January 9, 2023

Re: Comments on the Stibnite Gold Project Supplemental Draft Environmental Impact Statement

Figure 1 - Map of millsite claims

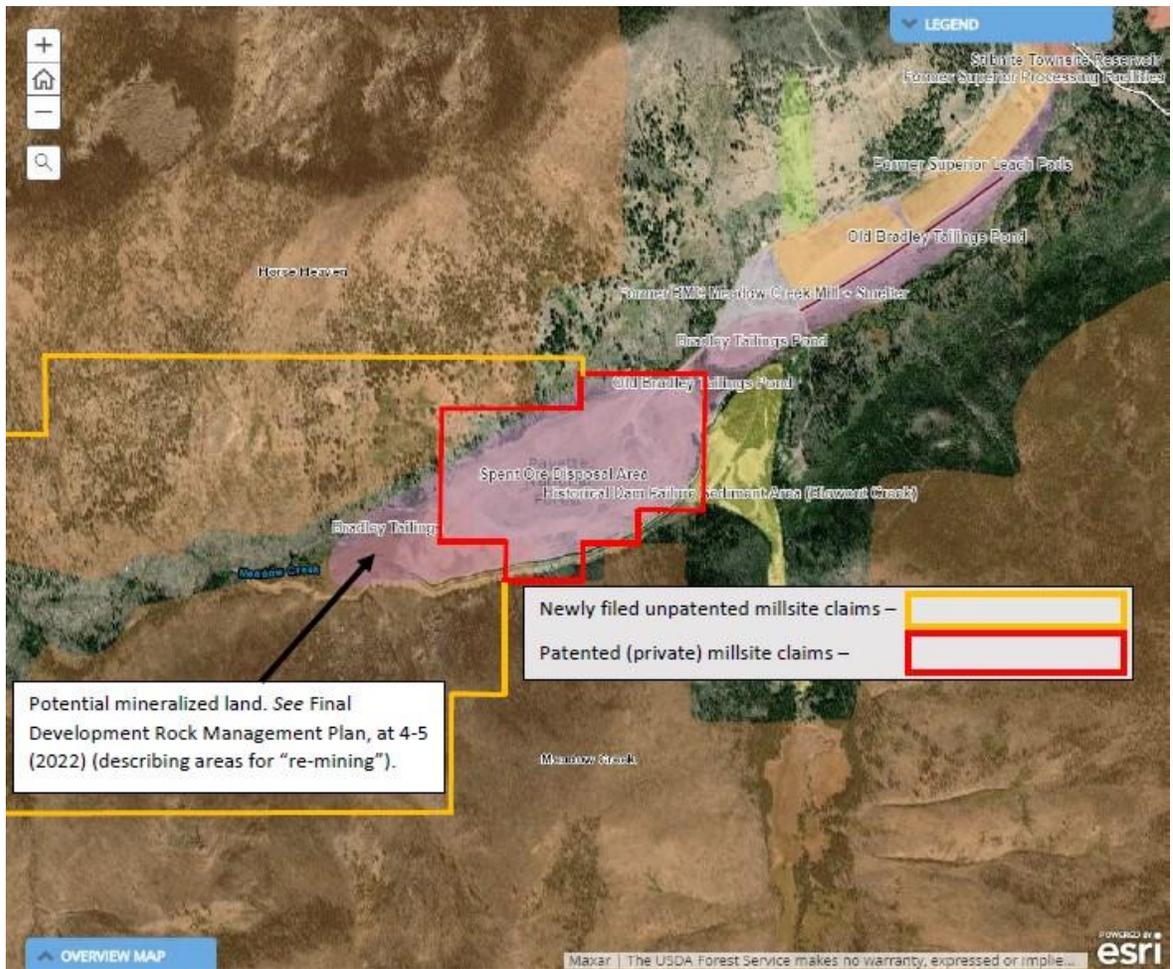
Commenters have provided the following map to illustrate where these new millsite claims are located in relation to historic and proposed mining claims and features. *See* Figure 1 and 2 below. Under the United States mining laws, millsite claims associated with a “vein or lode” must be located on “nonmineral land not contiguous to the vein or lode” and may not exceed five acres in size. 30 U.S.C. § 42(a). Additionally, the number of millsites a claimant can locate may be dependent upon the number of “associated” mining claims that meet the patenting requirements to ensure a one-to-one ratio between the two types of claims. Accordingly, if there are 188 unpatented mill site claims that were located and filed with BLM on September 1, 2022, there should also be 188 unpatented lode claims that meet the requirements necessary for patent, i.e., the claims must be valid because a discovery has occurred within the boundaries of the claim. *See* 30 U.S.C. §§ 26 and 29; *see also United States v. Cameron*, 252 U.S. 450, 460 (1920) (“All must conform to the law under which [mining claim patents] are initiated; otherwise they work an unlawful private appropriation in derogation of the rights of the public.”). Because it appears that the mineral resources proposed to be mined for the SGP are located almost entirely on private lands, it is unclear

It also appears that at least 15 of the new millsite claims are located on top of an area that is proposed to be “re-mined” under the 2021 MMP. *See* Figure 1 and 2 below. *See also* Brown & Caldwell, Final Development Rock Management 4-5 (May 2022) (describing “plans to re-mine and reprocess the Bradley tailings deposited in the Meadow Creek Valley located within the planned footprint of the proposed TSF. . . . Other legacy materials that constitute tailings from pre-Bradley milling operations are likely present and commingled with the Bradley era materials in the area beneath the SODA as well as in adjacent areas”); *Id.* at 5-2 (map depicting core holes west of the SODA and Bradley tailings on National Forest lands).

Because the plan to “re-mine” this area indicates the presence of mineralized land beneath the 15 (and perhaps more) millsite claims, the mill sites do not qualify as “nonmineral land” under the United States mining laws. Millsites identified as potentially being over-filed on land that is not “nonmineral” are: TSF-A-157; TSF-A-144; TSF-A-126; TSF-A-125; TSF-A-124; TSF-A-123; TSF-D-1; TSF-D-2; TSF-D-3; TSF-D-4; TSF-C-1; TSF-C-2; TSF-C-3; TSF-C-4; TSF-B-2. **This list is not exhaustive.** Depending on the extent of “re-mining” that occurs in this area, other millsite claims may overlay mineralized land. In any event, the Forest Service must determine whether the millsites are valid. *These comments also incorporate by reference the map depicting locations of the newly filed unpatented mill site claims in relation to other mine site features—which is similar to maps in Figures 1 and 2 below—that is included on page 12 of the comments from the Nez Perce Tribe.*
